MEMORANDUM

Subject: **SLUP 16-021:** CQ Dunwoody Village Court, LLC, owner of 1530 and 1536 Dunwoody Village Parkway, Dunwoody, GA 30338, by Marian Adeimy, attorney for contract purchaser, seeks a Special Land Use Permit to waive the requirement for a development to come into full compliance with the Dunwoody Village Overlay District regulations to allow for reduction in sidewalk width from 12 ft. to 6 ft. The property consists of two tax parcels: 18 366 06 061 located at 1530 Dunwoody Village Parkway, Dunwoody, GA 30338, and 18 366 06 065 located at 1536 Dunwoody Village Parkway, Dunwoody, GA 30338.

CROSS SECTION A

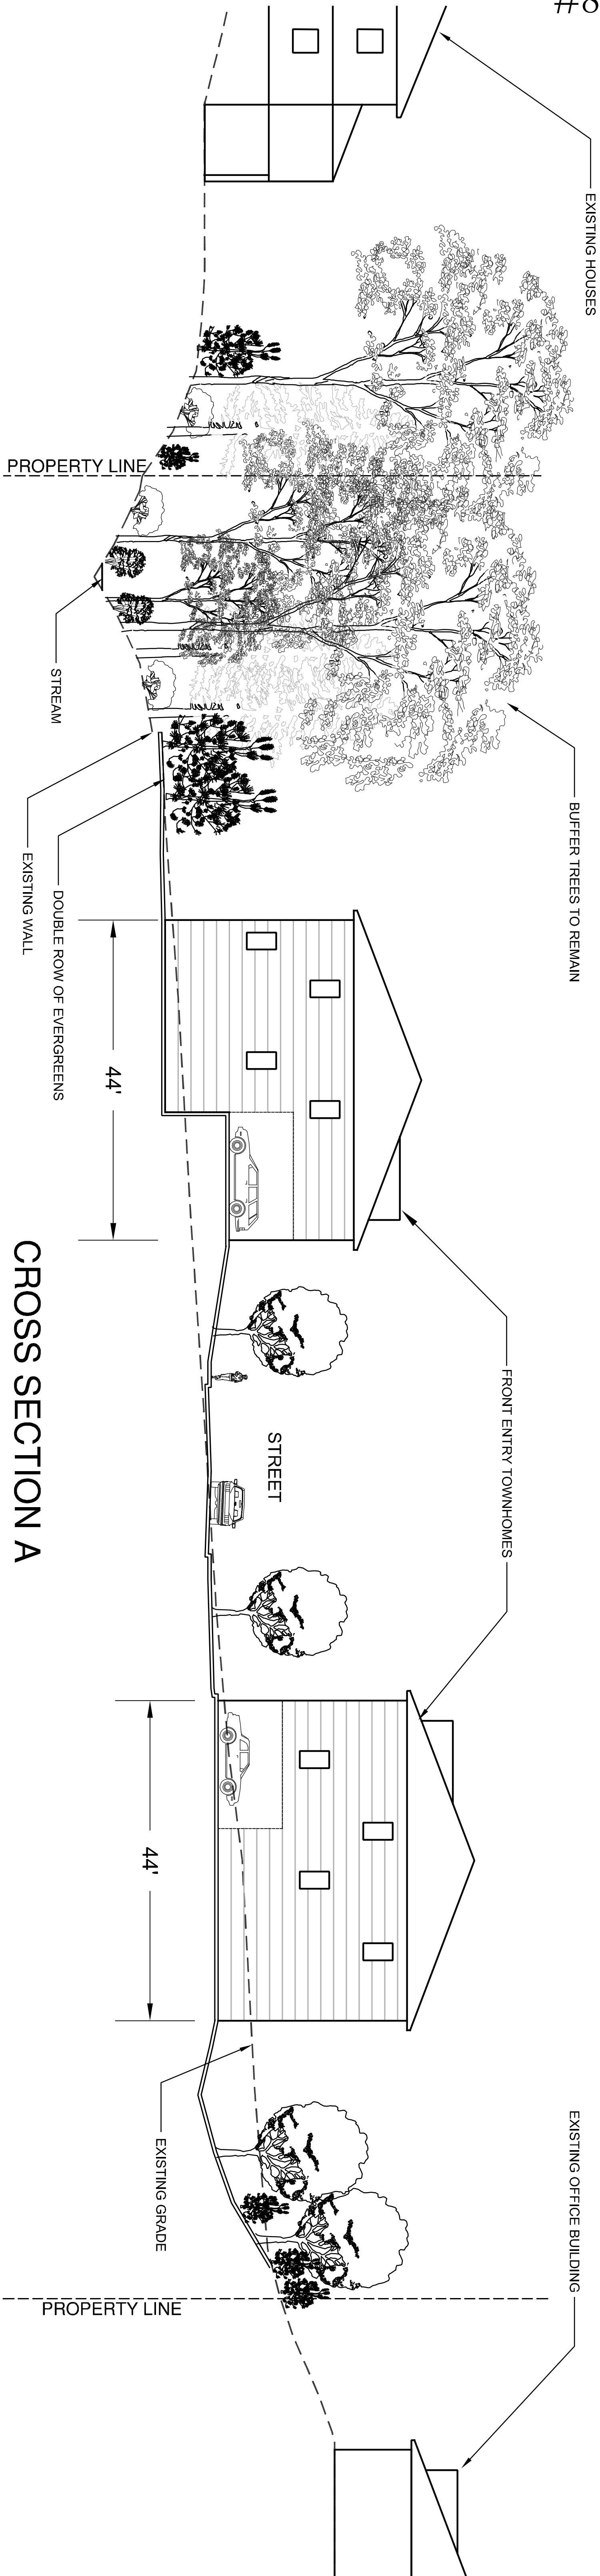
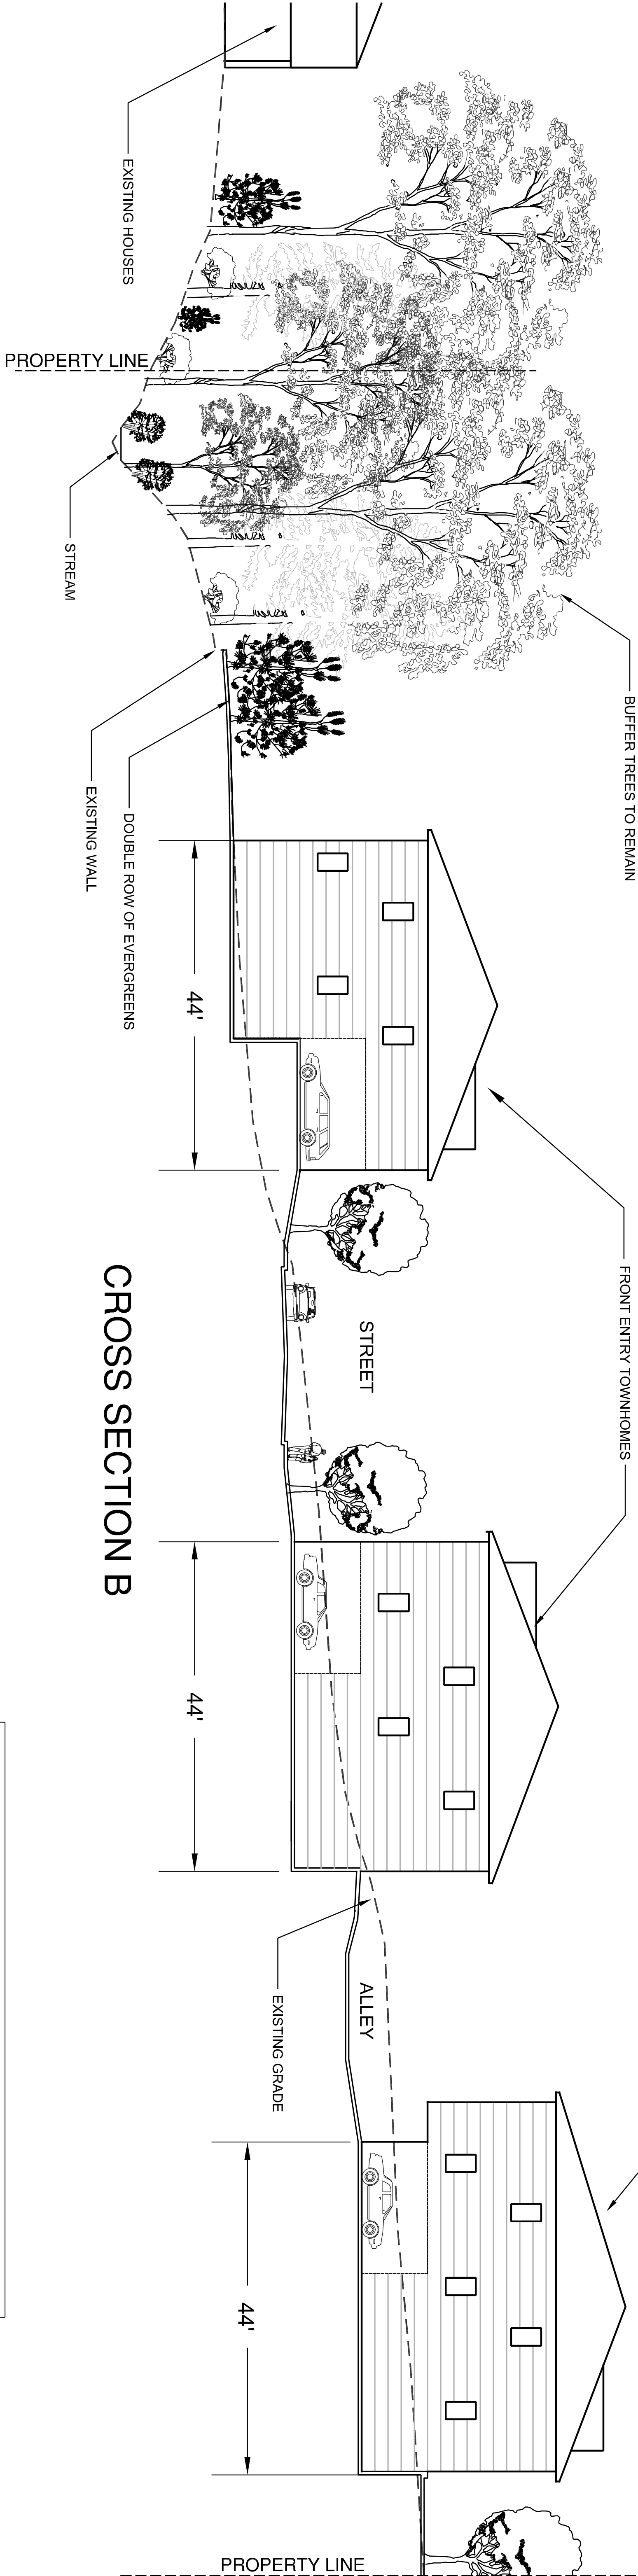
The Planning Commission motion clearly stated that the sidewalk was to be a minimum of six (6) feet wide, with the final width to be worked out with staff. Staff and the applicant have not come to a consensus on the acceptable sidewalk width. Staff is preparing cross-sections illustrating different sidewalk width scenarios for Council review.

Although a twelve (12) foot wide sidewalk along Dunwoody Village Parkway would provide additional space for pedestrian movements in a commercial context where other interactive functions are accommodated, an eight (8) foot wide clear path may be acceptable, at a minimum, for a residential project such as the current townhome use. To maintain functionality, the eight foot path will be designed to maintain the entire width as clear space for pedestrian travel. Staff has provided an eight (8) foot wide "clear" cross-section drawing, Exhibit A, for Council consideration.

Staff recommends that the City Council approve the SLUP subject to substantial compliance with the attached drawing, showing an eight (8) foot minimum sidewalk, as Exhibit A to this SLUP.
